Project: **Brick Breeden Fieldhouse – West Entrance Roof Retrofit**
Montana State University – Bozeman, Montana

END OF ADDENDUM #2

SHEET
S2.1

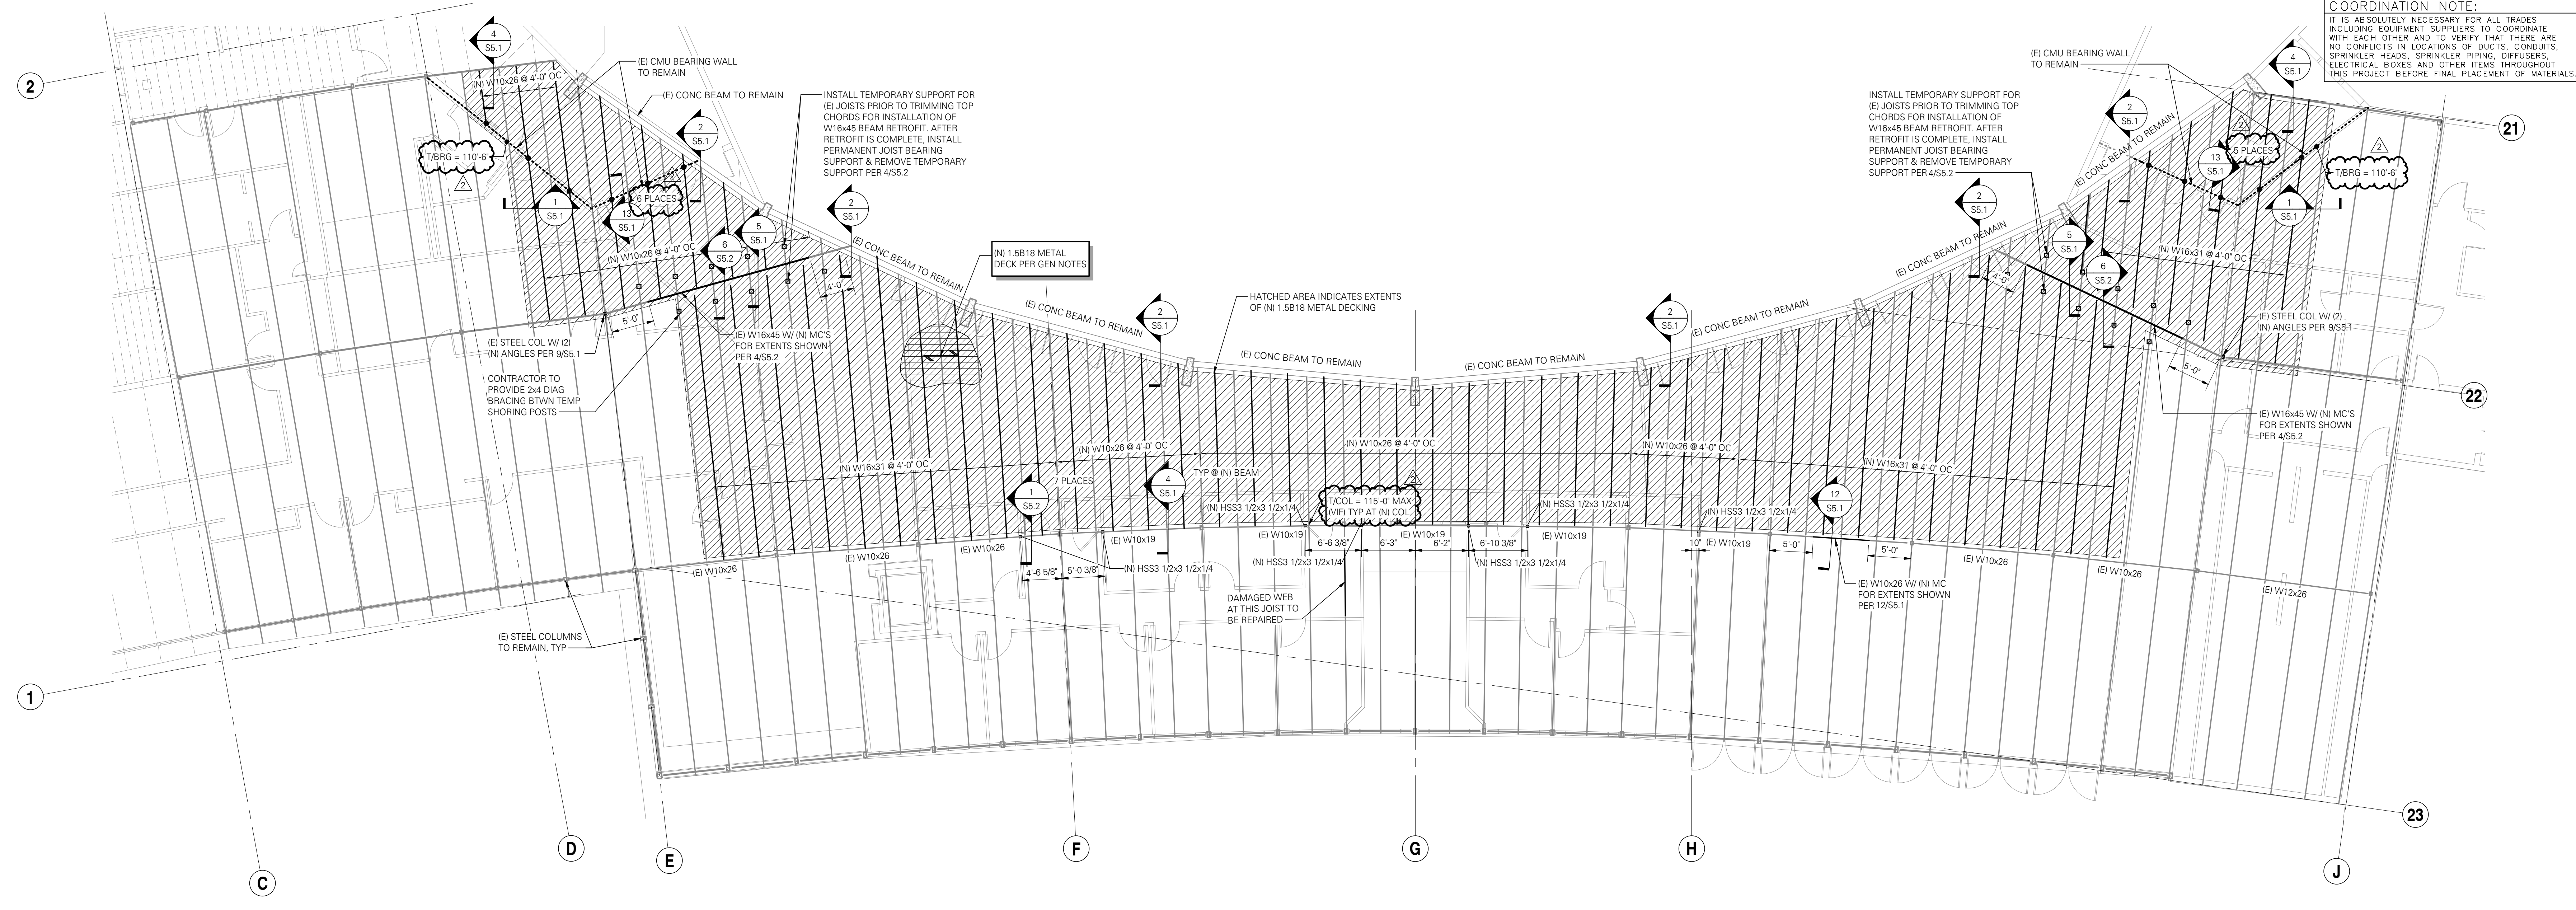
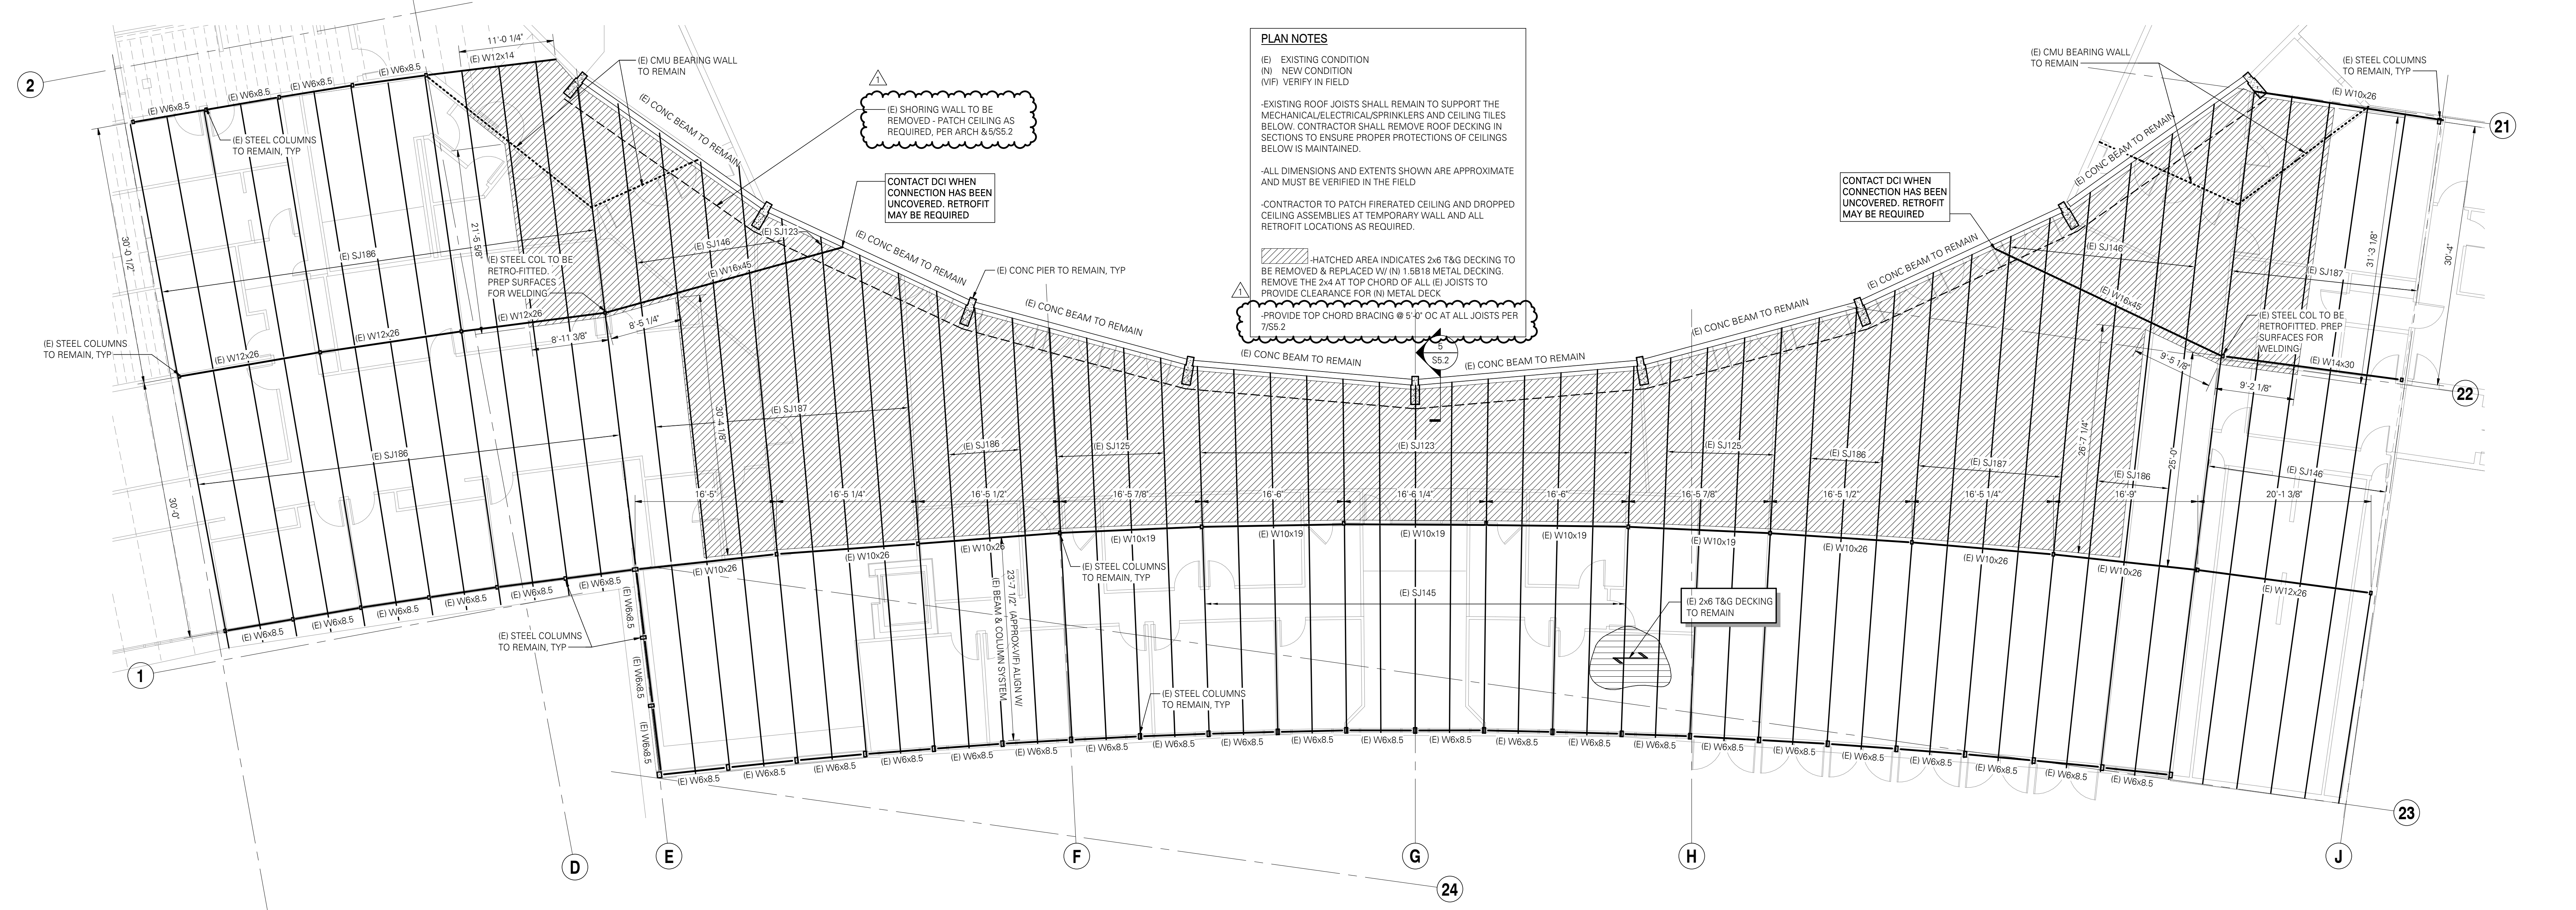
- Added approximate beam bearing elevation T/BRG = 110'-6" at existing CMU wall for new steel beam and to note height of existing CMU wall to be fully grouted per 13/S5.1. This condition occurs at 6 places at Grid E, and 5 places at Grid J. Final height to be verified in field.
- Added approximate column height T/COL – 115'-0" at Grid G at new HSS 3-1/2x3-1/2x1/4 columns. Final height to be verified in field.

3 NEW ROOF CONSTRUCTION - ROOF AREAS A, B AND C
 3/8"=1'-0"

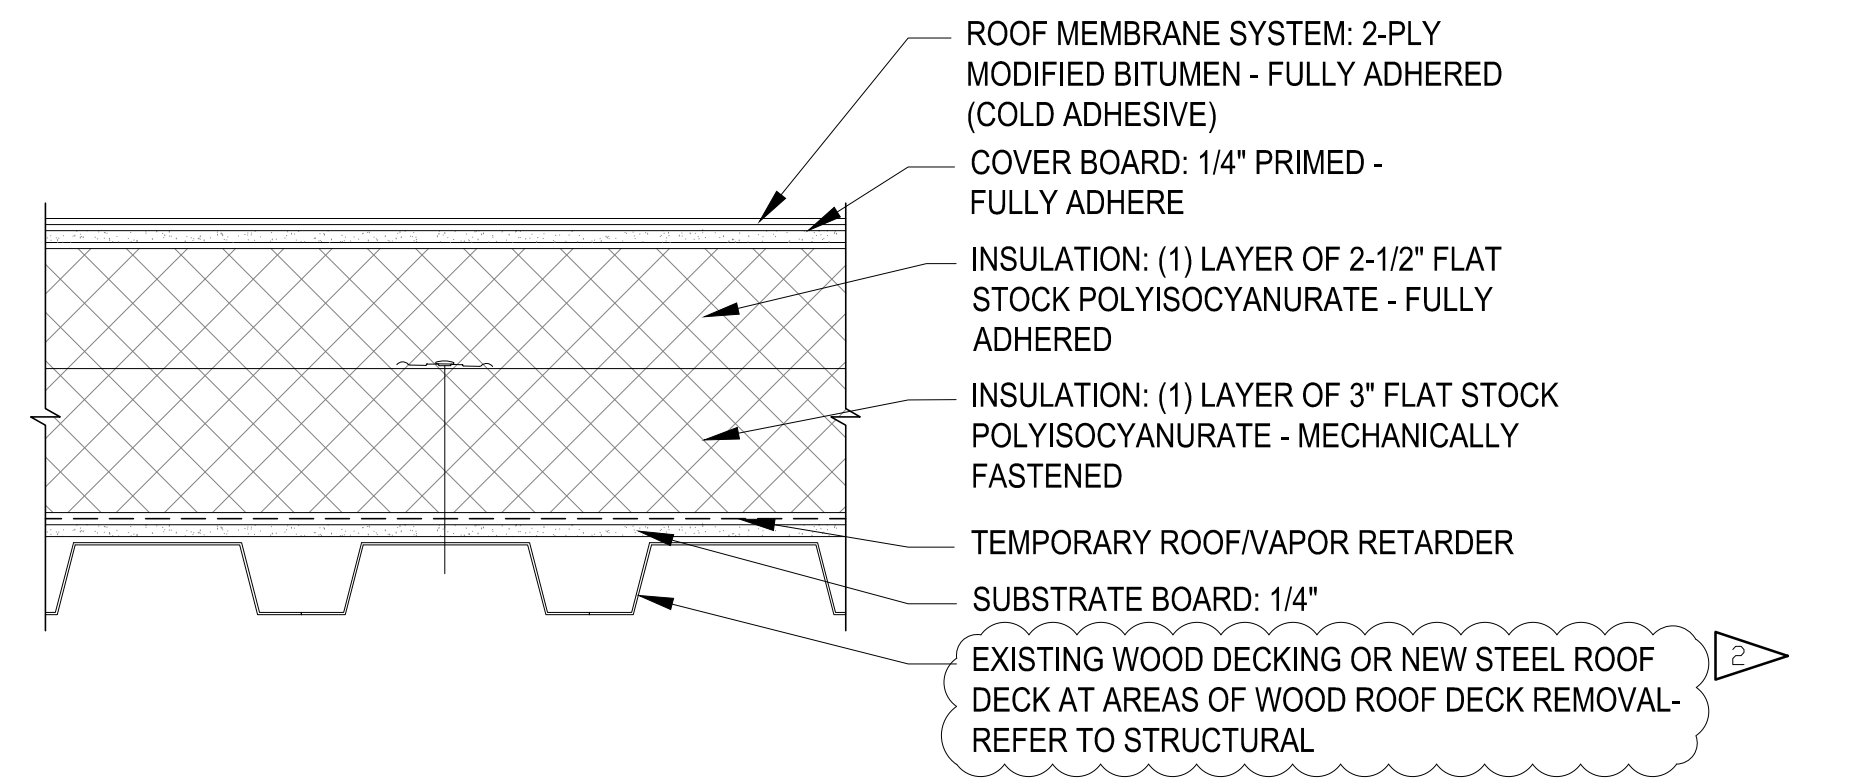
- **3/A1.1:** Revised note to refer to structural drawings for extent of wood decking removal.
